5.4. Shadow Impacts

5.4.1. Residential Towers at 118 and 140 Church Street

7. RECOMMENDATION

Figure 25: Shadow Impacts to residential towers at 118 and 140 Church Street

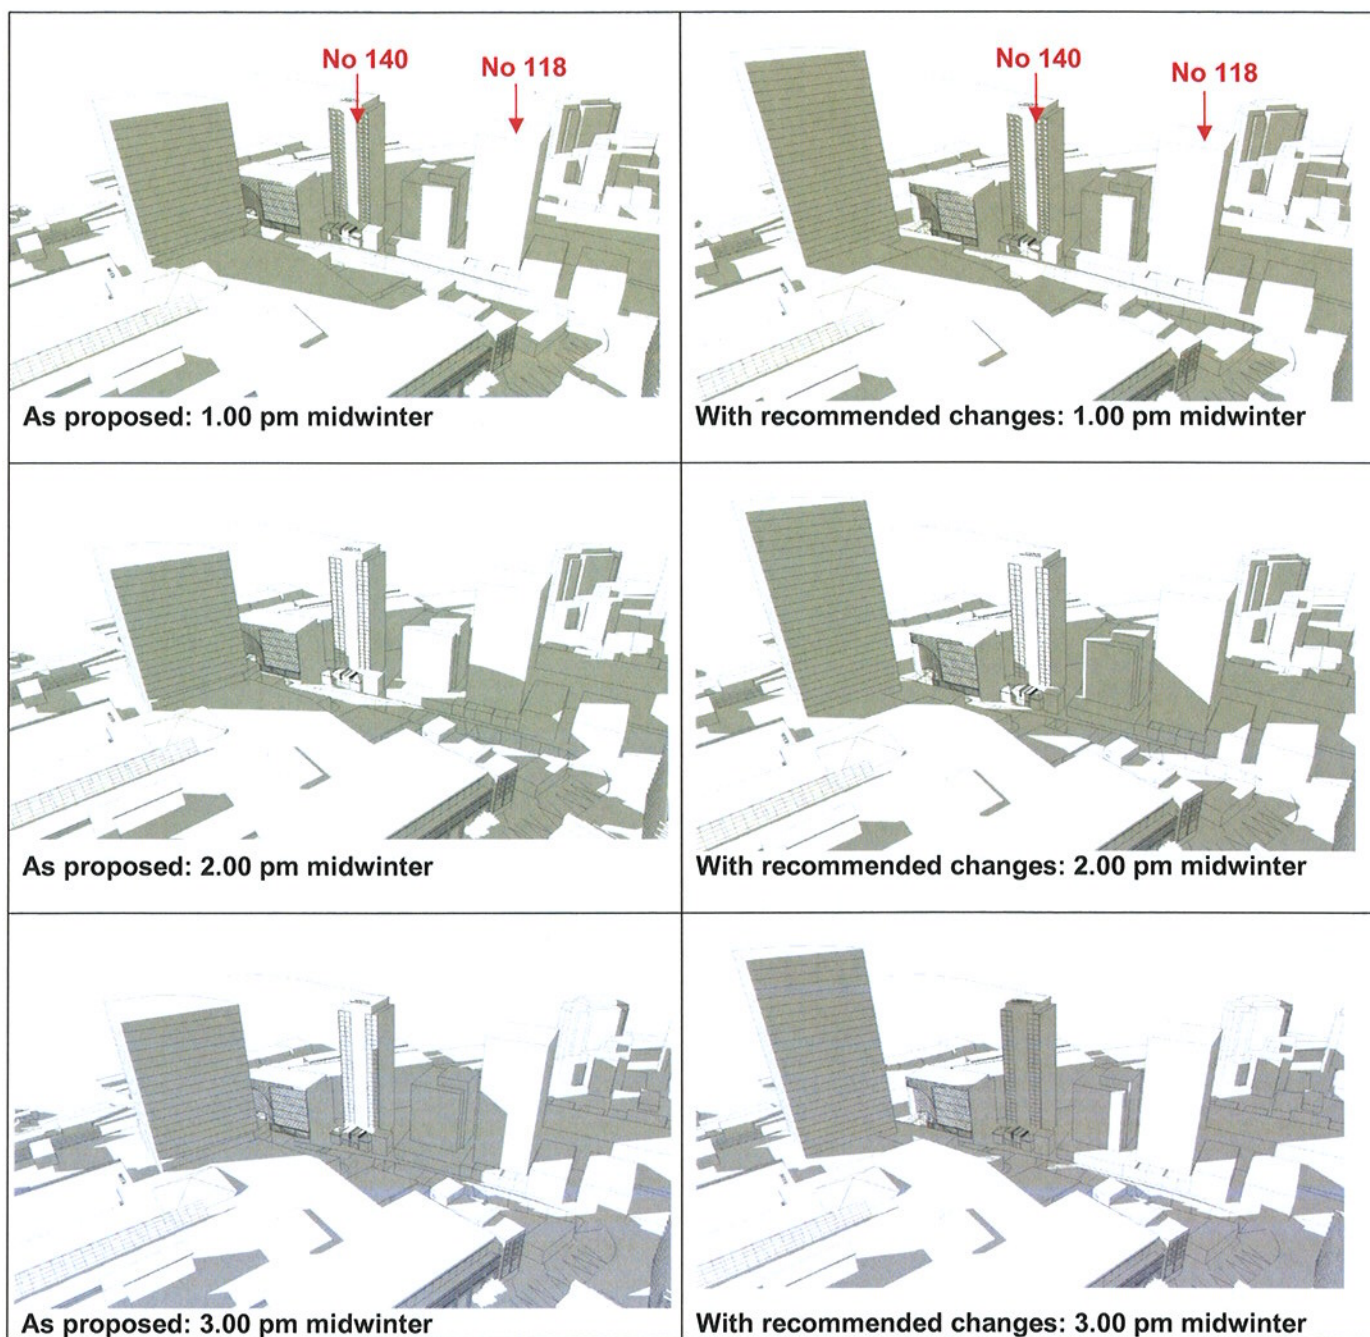
The shadow impacts of the future tower will be dependent upon the final design at DA stage, but shadow diagrams submitted by the proponent demonstrate that the built form likely to arise from the proposed envelope would result in no shadow impacts to 140 Church Street, but would overshadow some of the dwellings at No 118 Church Street from around 1.40pm onwards: Refer to **Figure 25**.

The Department has recommended changes to the tower location and built form as set out in **Section 5.3**, including relocation of the tower towards the north, reduced width and increased height. The Department acknowledges that those changes would now result in some shadow impacts to No 140 Church Street (likely between around 2.15pm and 3.00pm mid-winter), but would also result in improved solar access for the other nearby residential tower at 118 Church Street. Refer to **Figure 25**.

The Department considers that the overshadowing impacts of either scheme are acceptable in this case. The site is located within a high density central CBD environment where higher levels of overshadowing are to be expected. Furthermore, dwellings on the western façade are constrained by their orientation, being in self shadow for most of the day. While some of the dwellings on the western façades would not receive 2 hours of solar access mid-winter under the proposal, all dwellings would receive at least some solar access mid-winter and excellent solar access at other times of the year. Due to good levels of solar access provided to the northern and eastern facades of those buildings, the Department considers it likely that at least 70% of dwellings within each building would retain 2 hours of solar access at mid-winter, in line with the standard recommended by the Residential Flat Design Code, and on this basis the extent of overshadowing is not considered unreasonable or unacceptable.

Figure 27: Shadow diagram indicating extent of overshadowing from the proposal on the Cemetery.

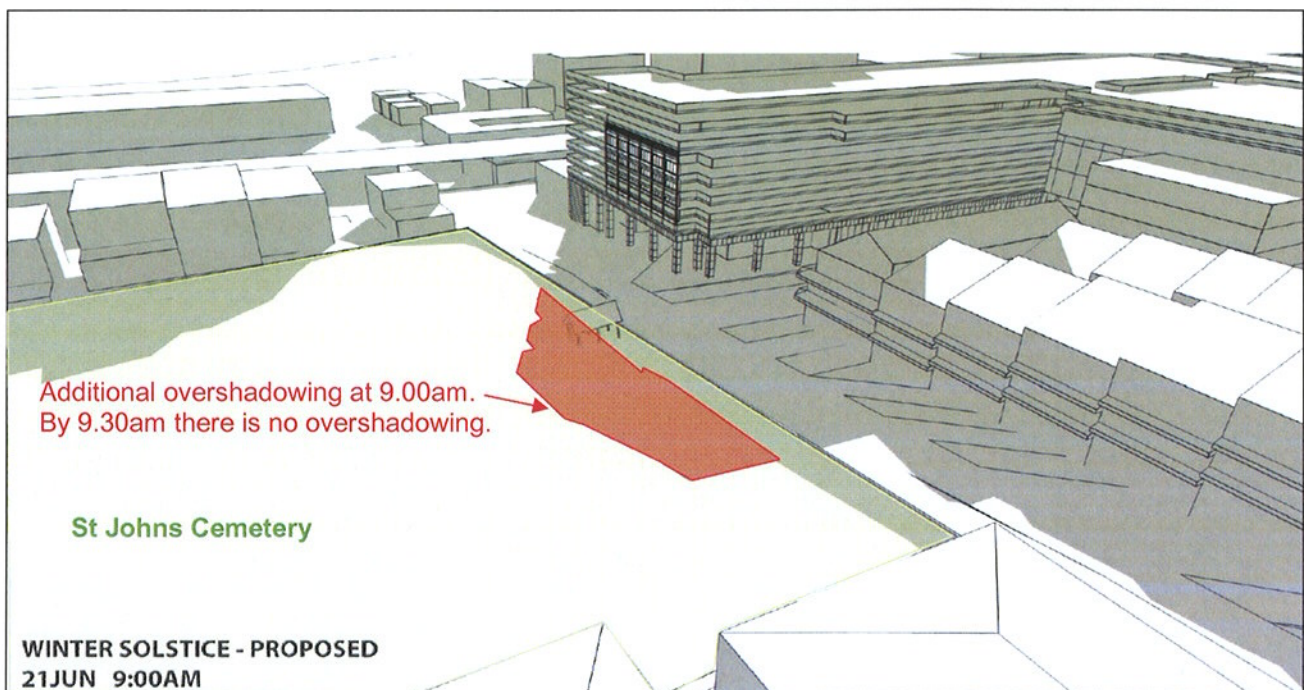
The cemetery is located to the west of the site (refer to **Figure 28**), and is also on the State heritage register. It is also significant for its association with notable people. The Heritage Office raised concerns about the impact of the proposed extensions, particularly due to overshadowing on the cemetery.

Detailed shadow diagrams prepared by the proponent demonstrate that the proposed extensions will result in a small area of the cemetery being overshadowed between 9.00am and 9.30am mid-winter (shown in **Figure 27**), but that at all other times of the day and all other times of the year the cemetery receives excellent solar access and is not affected by the proposal. The Department therefore considers that the small extent of overshadowing is not considered to materially affect the significance of the heritage item.

Figure 30: Visualisation showing recommended tower envelope as viewed from front entrance of Old Government House currently, and with future Marsden Street development (Source: Parramatta City Council)

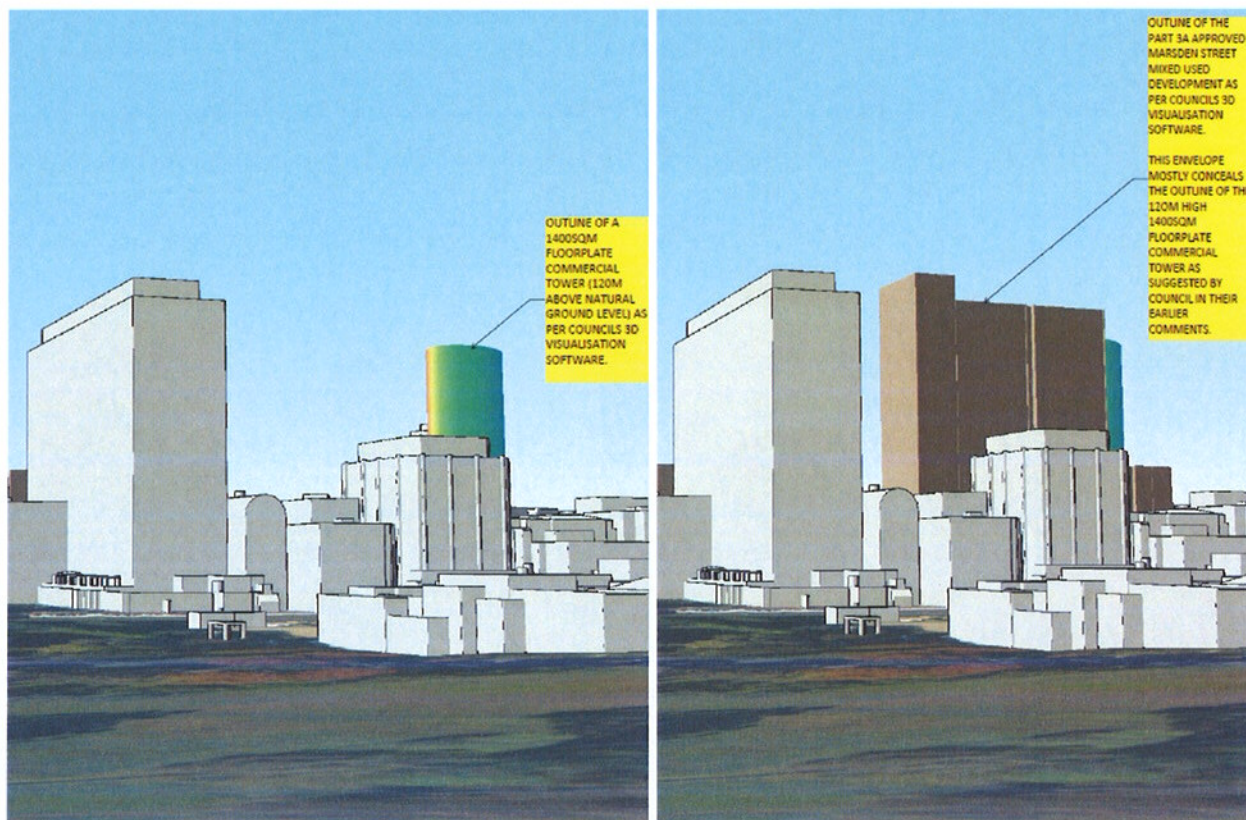
However, it is considered that a taller narrower tower on the site, as recommended in **Section 5.3.3** above will not result in any further impacts on the heritage significance of Old Government House and Domain. A photomontage of the proposed tower at **Figure 29** demonstrates that any tower in this location would not be highly discernible through the intervening trees. Further, an approved Part 3A development on Marsden Street (MP09_0167), if built, would obscure most views of the tower as demonstrated in **Figure 30**. Further, if the tower were to be relocated slightly north on the site as also recommended in **Section 5.3.3**, it would be completely obscured by the intervening Marsden Street development.
